VERMONT YANKEE NUCLEAR POWER CORPORATION

FVY 84-95

Subject: Supplemental Information Regarding the Vermont Yankee 1984
Refuel Outage Augmented In-Service Inspection Program

VIEW PIPE

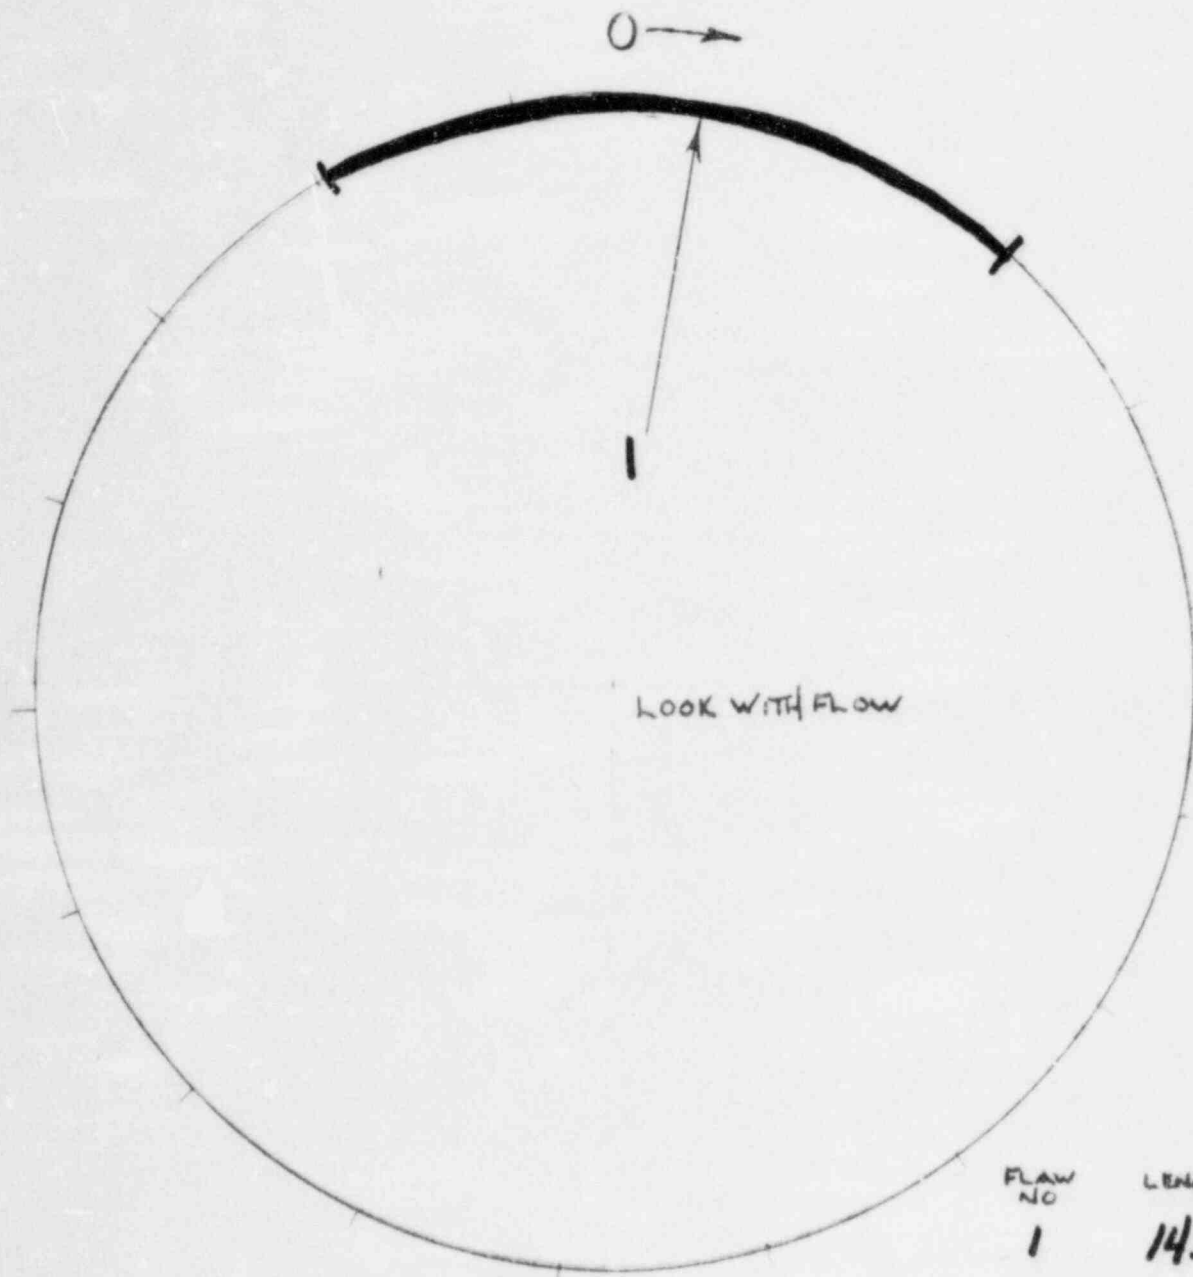
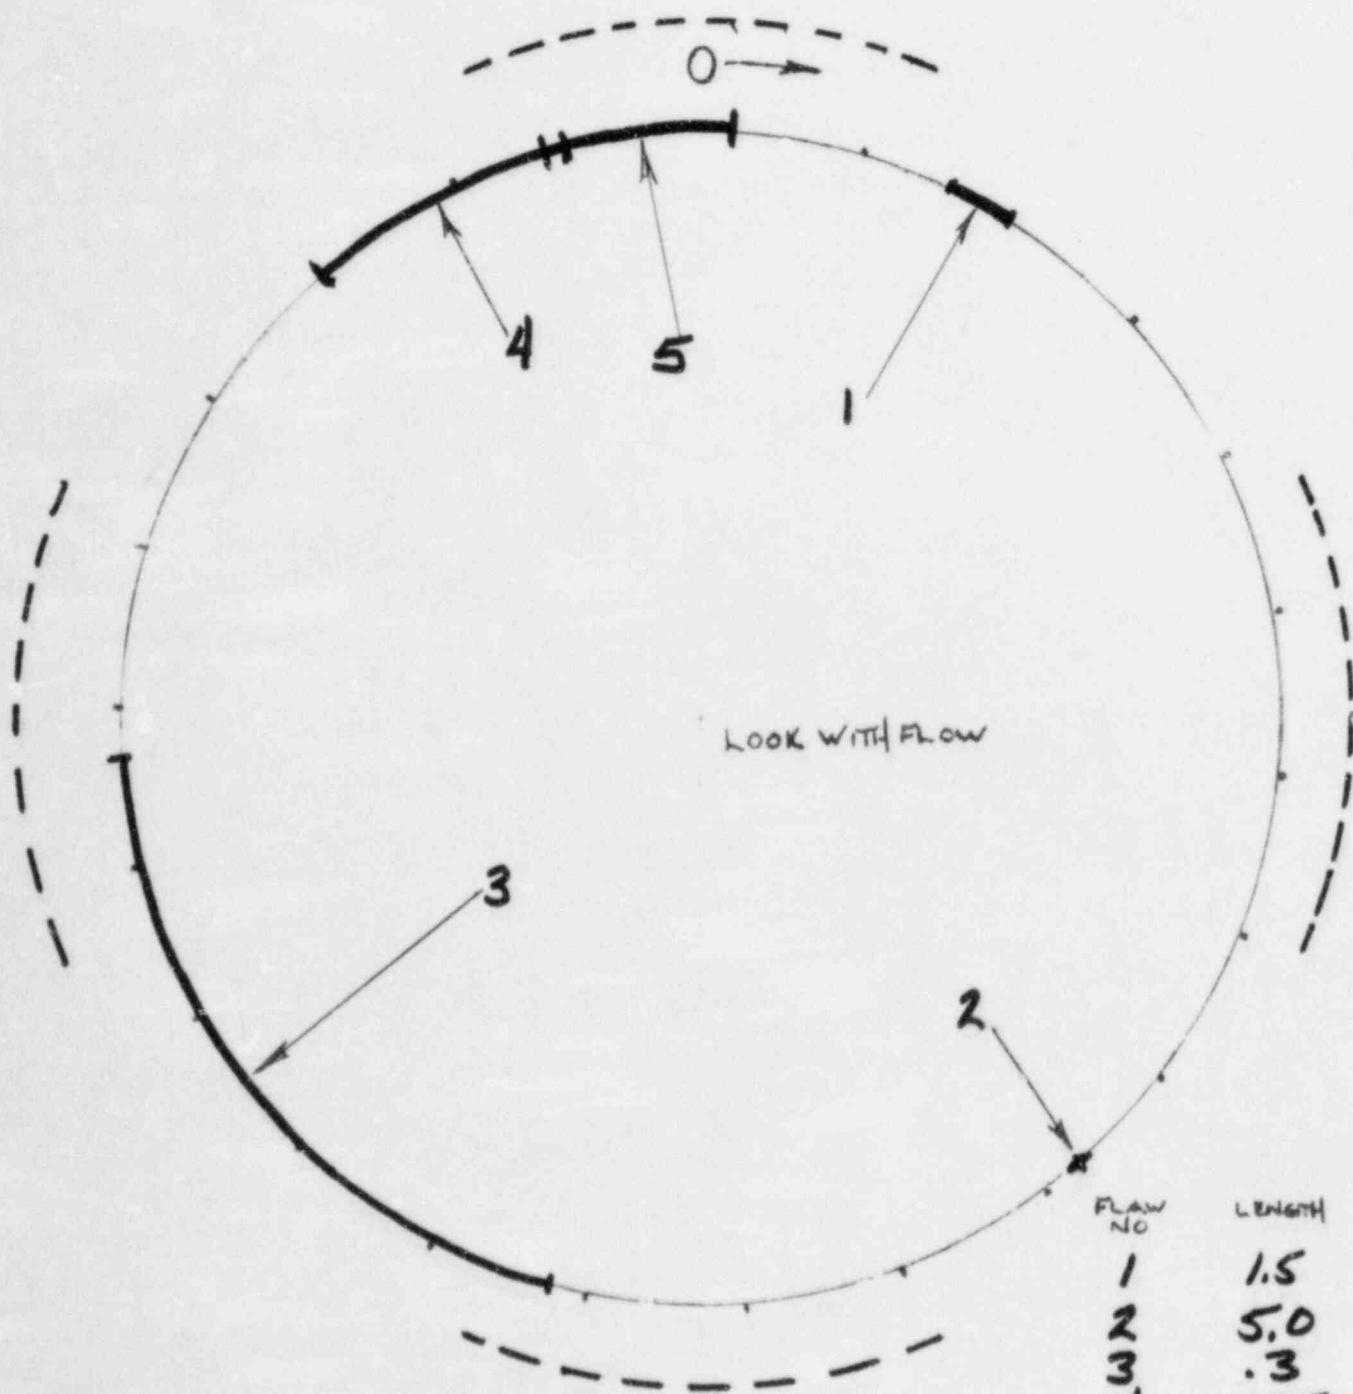
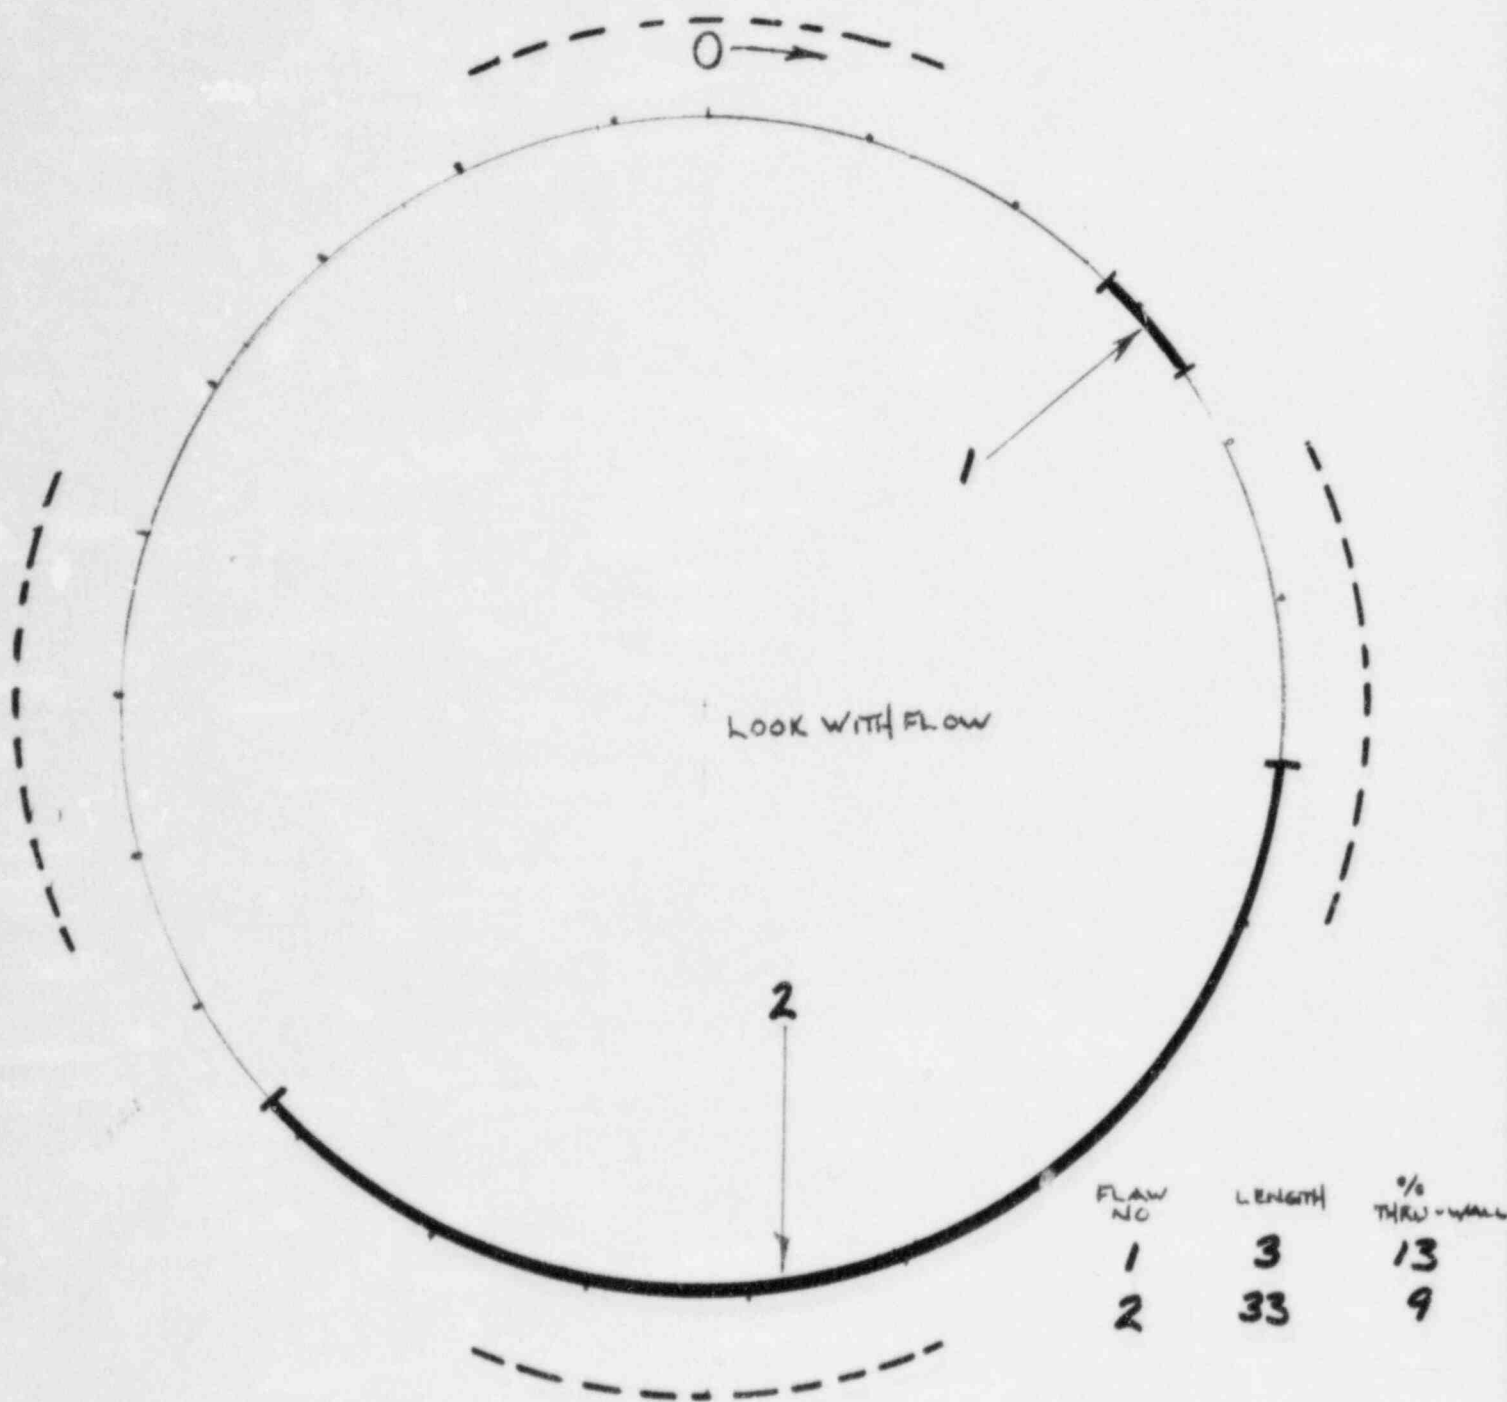
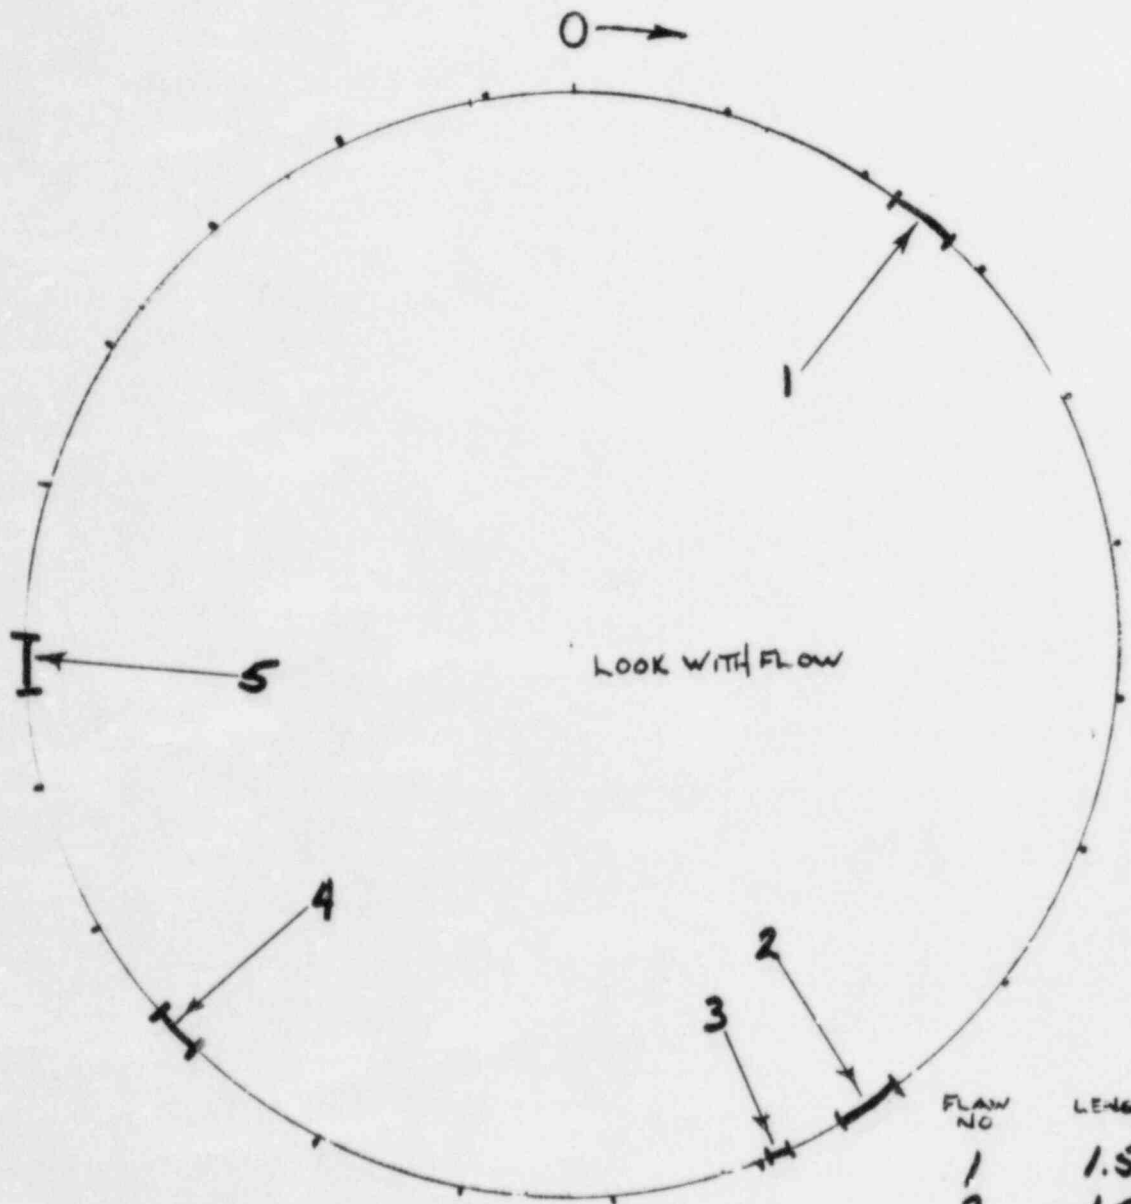
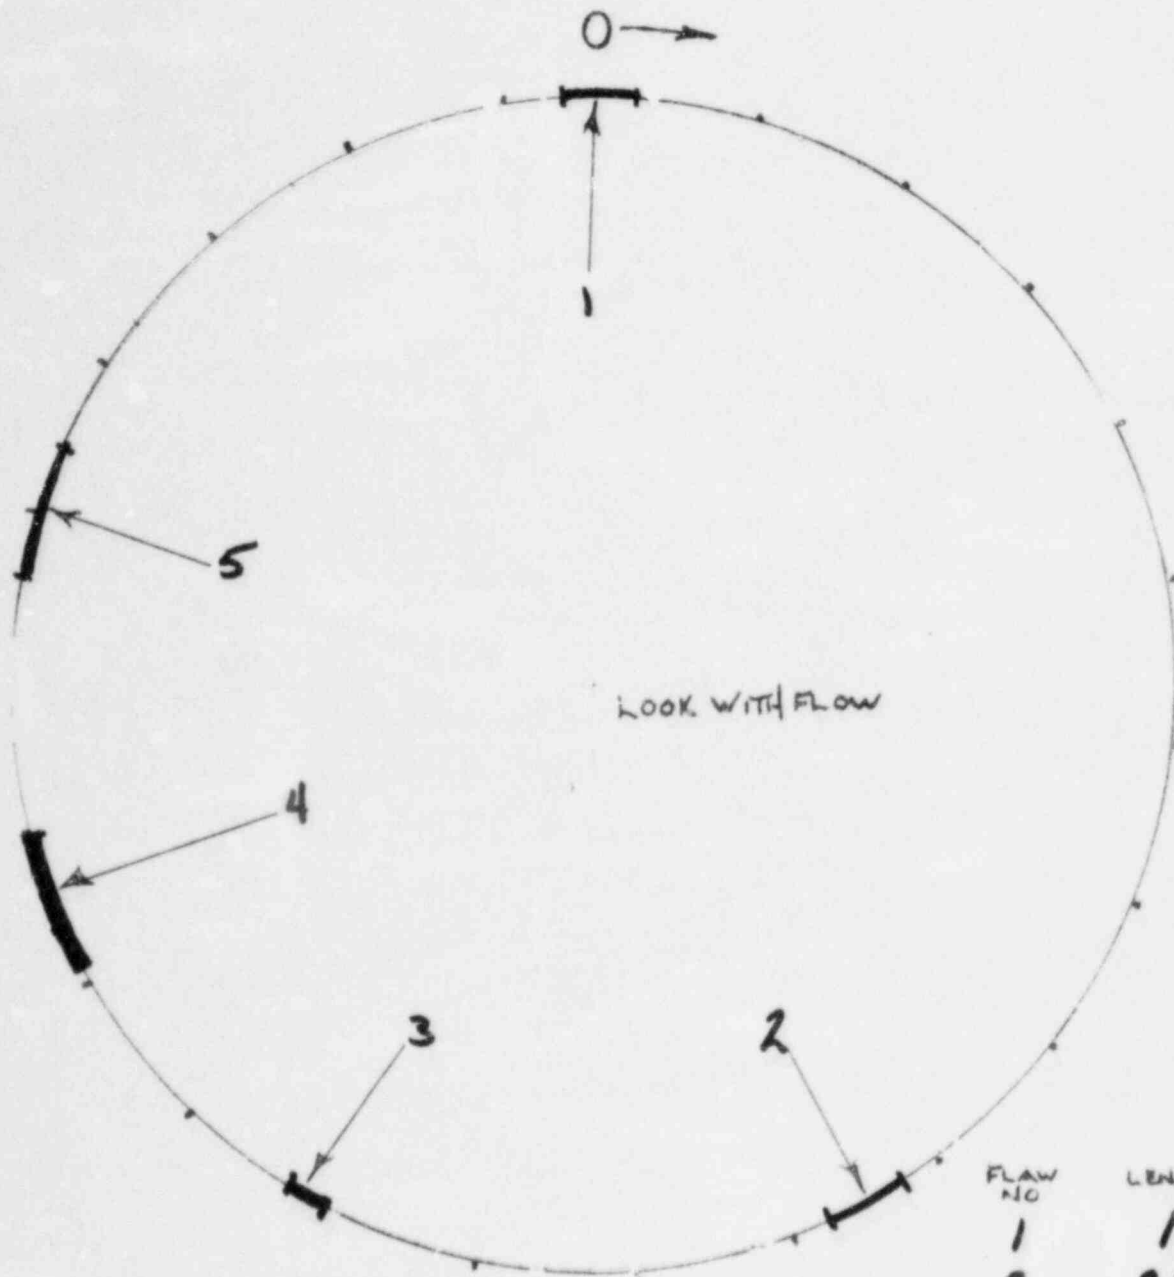
4. Table VIII of our Final Report provides a summary of weld joint flaws for 1983. Your Staff requested that we submit weld flaw diagrams for 1983 similar to those provided in Table IX of our Final Report.

Your Staff also requested that we describe the criteria for how we determined the flaw lengths for 1983. This information is provided in Attachment A to our Final Report; however, additional clarification was requested.

The requested weld joint flaw diagrams for 1983 are attached to this letter. These diagrams are supplements of Table VIII of our Final Report.

It should be noted that the 1983 flaw summary diagrams are reconstructions called "flaws" from 1983 examinations. In comparing the 1983 flaw diagram to the 1984 diagram, it must be recognized that the 0° points are not exact. In addition, neither the 1983 or the 1984 summary diagrams contain all recorded indications, but rather, they represent the end results of the detection and discrimination processes.

In 1983, the procedural requirements (which served as the basis for the I&E Bulletin 83-02 Qualification) were to carry the linear extent of an indication to the point where its amplitude dropped to one-half the maximum amplitude. In instances where indications continued for any distance at less than one-half maximum amplitude, the indication was continued over the full extent until the indication definitively dropped.
